### **ITEM # 3.0**

#### **PRELIMINARY & FINAL PLAT APPROVAL:**

Retama Phase VI Subdivision (Private)  
9.173 acres being out of Lot 14,  
Del Monte Irrigation Co. Subdivision  
PUD (R-1)  
Developer: Rhodes Development, Inc.  
Engineer: Melden & Hunt, Inc.

### **REVIEW DATA**

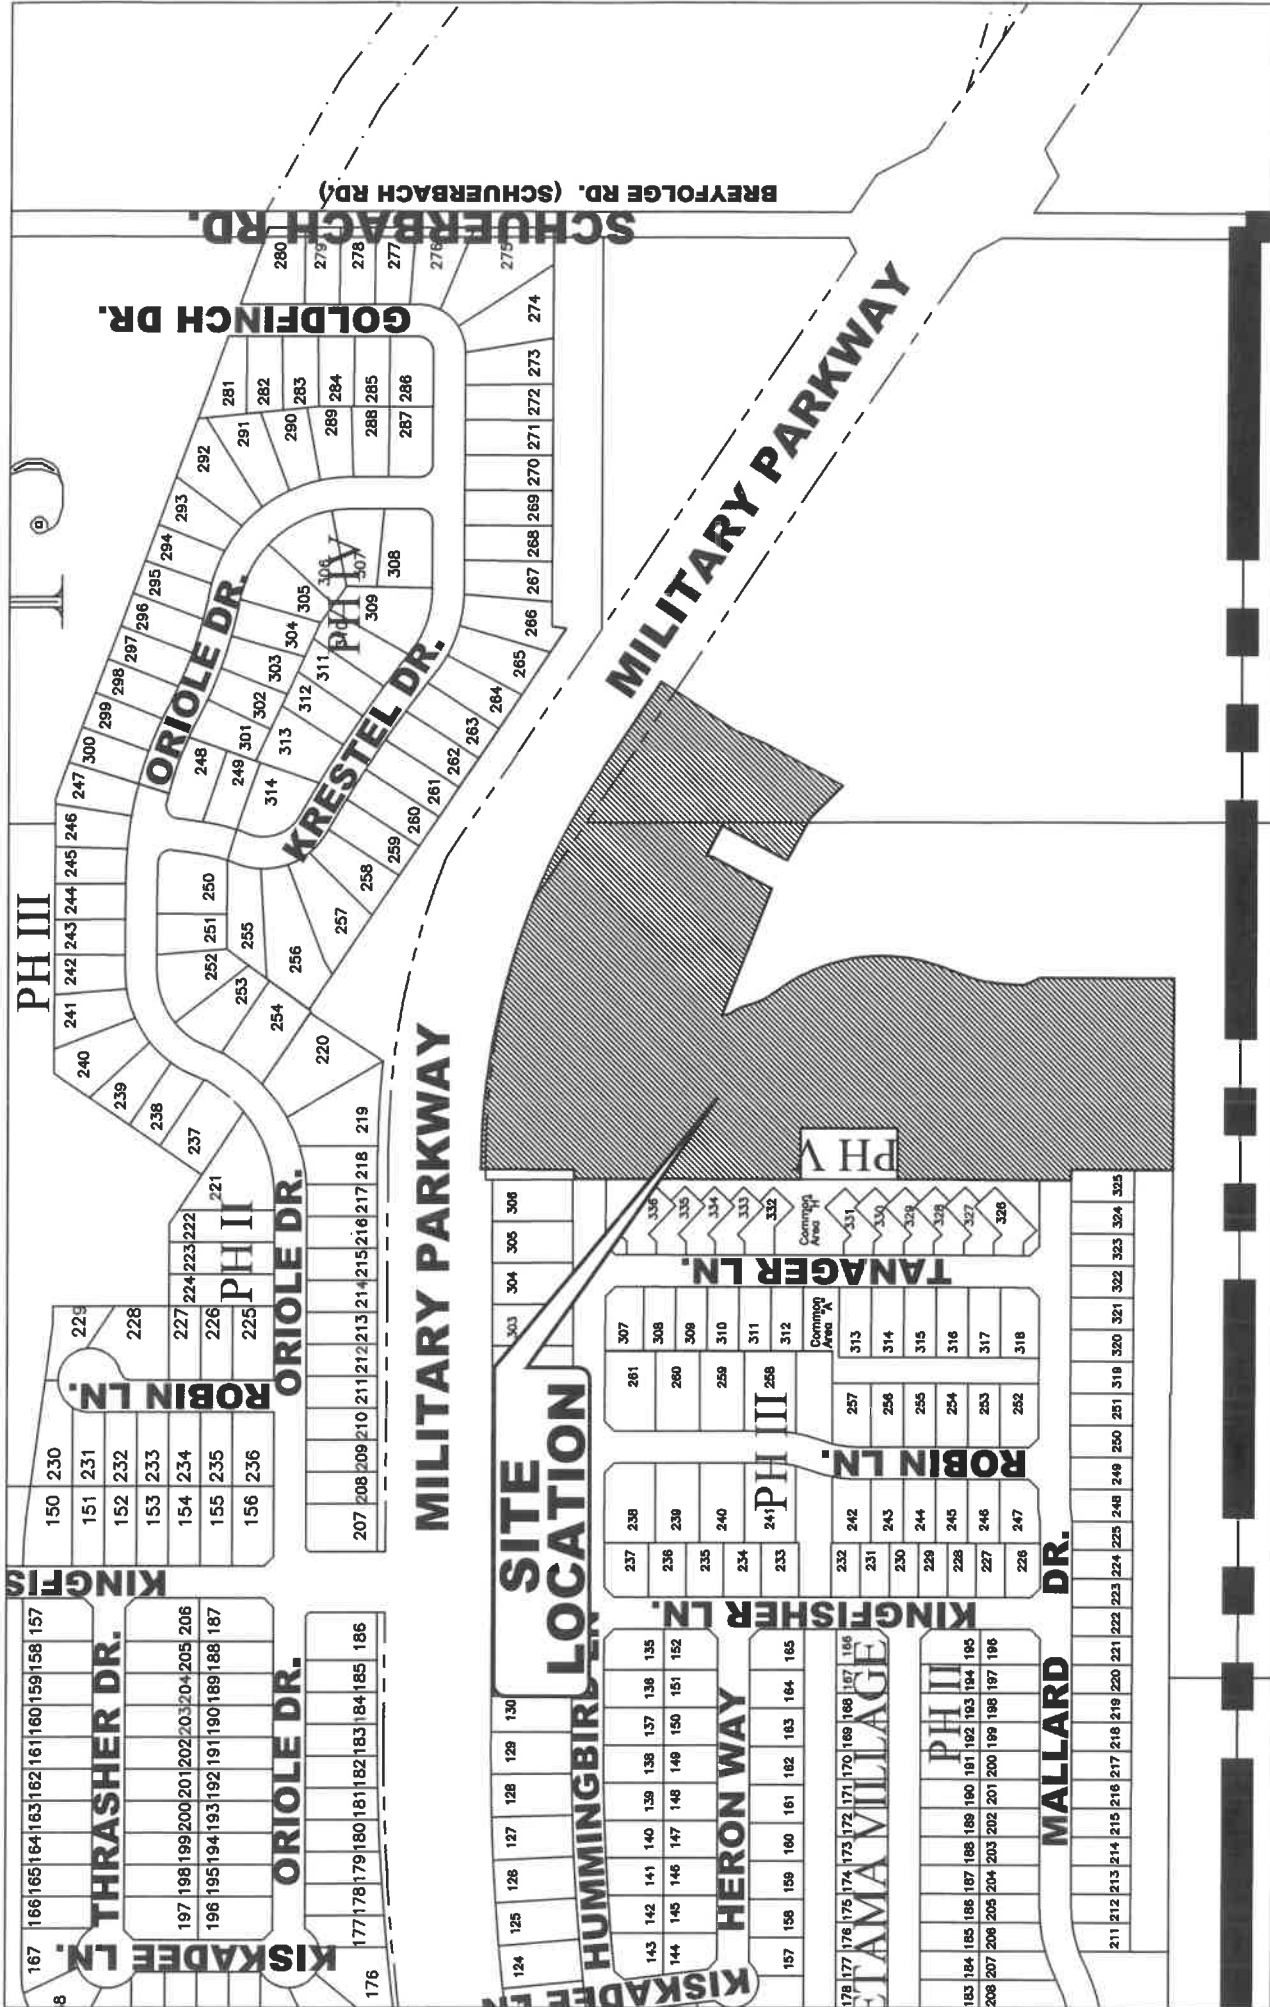
The proposed site is part of a master plan located on the SE corner of Bentsen Palm Dr. and Military Parkway East. — see **vicinity map**. This tract was vacant with a proposed land use for 20 residential lots, 22 cottage lots, and 3 common areas— see plat for actual dimensions, square footages, and land uses.

Request variance from Sec. 98-134 ‘Streets’ of the Code of Ordinances Ch. 98 - Subdivisions to allow the design and proposed construction of a 30’ ROW whereas the code requires streets within a subdivision to be at least 50’.

Request variance from Sec. 98-134 ‘Streets’ of the Code of Ordinances Ch. 98 - Subdivisions to allow a pavement width of 30’ whereas the minimum pavement width of minor residential streets shall have 32’ back-to-back

The developer is proposing to connect to an existing 8” water line located along the south R.O.W. of Hummingbird Lane and extend an 8” water line through the site providing water service to each lot. It will be looped to the south onto the existing 8” line which was stubbed by the Phase V development and to the existing 12” main line along the south ROW of Military Pkwy East. This system will be stubbed at Hummingbird Ln. and Mallard Dr. ends for future extensions. There are 3 proposed fire hydrants via direction of the Fire Marshal’s office. – see **utility plan**

The developer is proposing to connect to an existing sewer cleanout on the north side ROW of Hummingbird Ln., which was left for this purpose, and extend an 8” PVC line to collect from all lots abutting to this street which will end with a standard MH. Lots 346-372 will be serviced by an 8” sewer line located on the west side of the street to be connected to an existing 12” sewer main along the north side of Ballard Dr. which will collect from the remaining lots. All lots will be stubbed front-and-center with a 4” PVC line. The Capital Sewer Recovery Fee is required at \$200.00/Lot which equates to \$7,400.00 (\$200.x 37 Lots).

The subdivision will have 2 existing streets extended from phase V (Hummingbird L. and Ballard Dr.) to have dead-ends for future expansions with a main access to Military Pkwy East from

Hummingbird Ln. between Lots 340 & 341. This access will have an 80' ROW with median islands. The design will also include an internal street with a proposed paved 30' ROW.

This project was previously approved by P&Z on December 2023 and then by City Council on January 2024 which included both variance requests. The developer is now proposing to add 5 residential lots to the original submitted plat. Staff has no objection therefore recommends approval subject to payment of Capital Sewer Recovery fee and comply with items 1-4 shown above.
